ADDENDUM NO. 4
TO THE DRAWINGS AND PROJECT MANUAL
FOR
FIRE STATION
RACE TRACK LANE, LAKE CITY, FL
COLUMBIA COUNTY BOARD OF COUNTY COMMISSION

ARCHITECT'S PROJECT NO. 0715

CRAIG SALLEY & ASSOCIATES, ARCHITECTS, GAINESVILLE, FLORIDA

REVISED ROLL-UP DOOR HEAD DETAIL

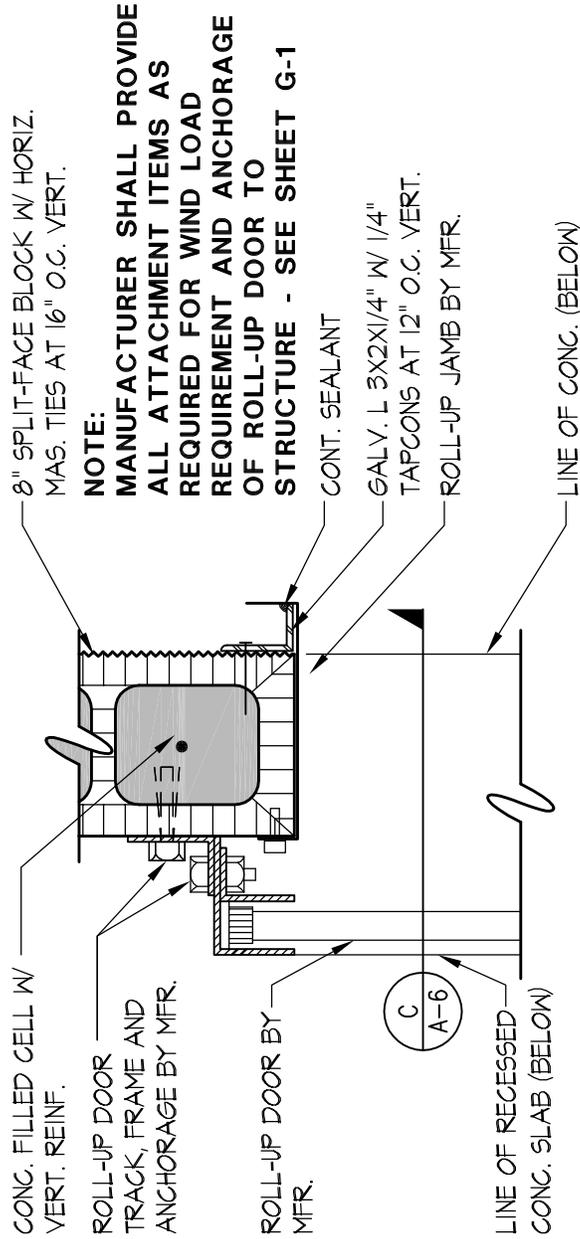
4. **DRAWINGS, SHEET A-6 – BUILDING SECTIONS:** Refer to Roll-Up Door Head Detail A/A-6 and Roll-Up Door Jamb Detail B/A-6 and replace them with Attachments "A" and "B" which revise these details and increase the size of all the metal building girts to 10" deep, as required for the 140 M.P.H. wind loading. Make all adjustments throughout the Documents required to accommodate this change.
